TO: Sydney Central City Planning Panel

SUBJECT: 4-12 Railway Street LIDCOMBE NSW 2141

APPLICATION No: DA2021/0092

Figure 4 – Extract of proposed Height Plan Diagram (Source: Loucas Architects, 2021)

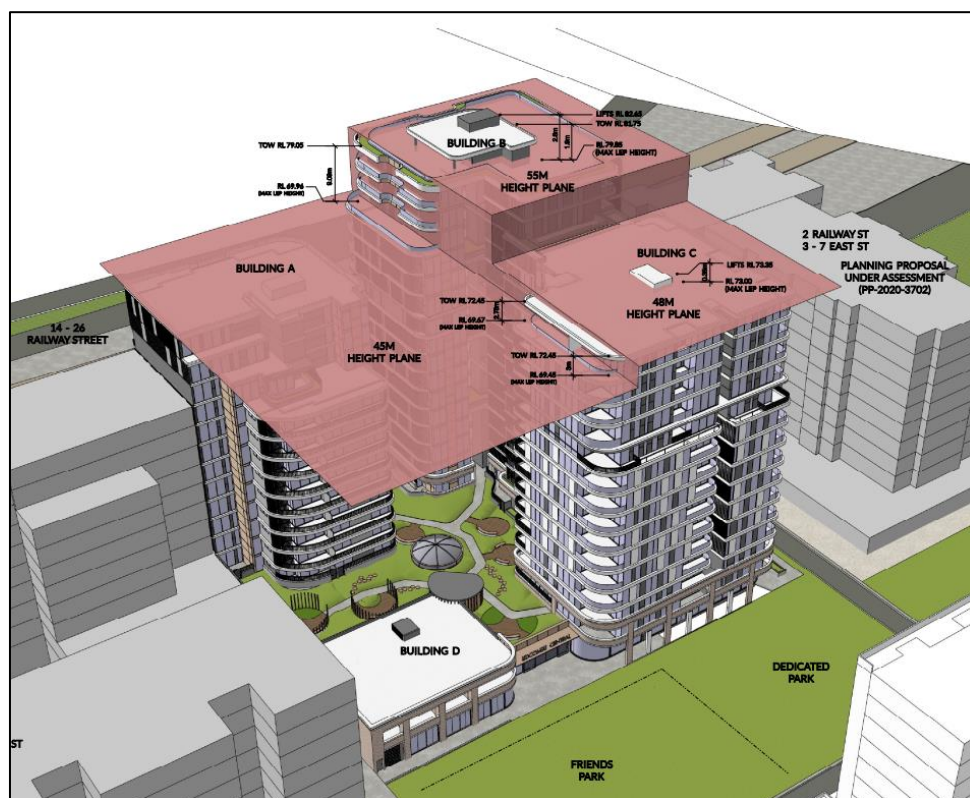
<p>metres (6.6% variation). Please refer to Figure 4 following this Table.</p> <p>No portions of Building C that exceed the maximum building height comprise habitable floor space.</p>
<p>4.4 Floor space ratio 5:1 maximum floor space ratio</p> <p>Plus 0.3:1 bonus if the floor space ratio for the part of the buildings used for non-residential purposes is not less than 0.6:1.</p> <p>Total maximum FSR 5.3:1</p>	Y	<p>The development provides a total non-residential gross floor area (GFA) of 3,460m², which equates to a total FSR of 0.6:1.</p> <p>The development maintains a total gross floor area of 29,763m².</p> <p>The total GFA equates to an FSR of 5.21:1.</p>

The lift overrun and balcony portions of Buildings B and C that exceed the maximum building height do not comprise any habitable floor area and are not capable of being converted to habitable floor area. The numerical variances sought, are considered to be reasonable, in that they do not add any unnecessary bulk to the building, given the minor nature of the numerical departure. It is acknowledged that the transfer of the non-compliant portions of the building to the western portion of the site, whilst resulting in compliance with the development standard, would conflict with the solar access requirements for Friends Park and the portion of open space to be dedicated.
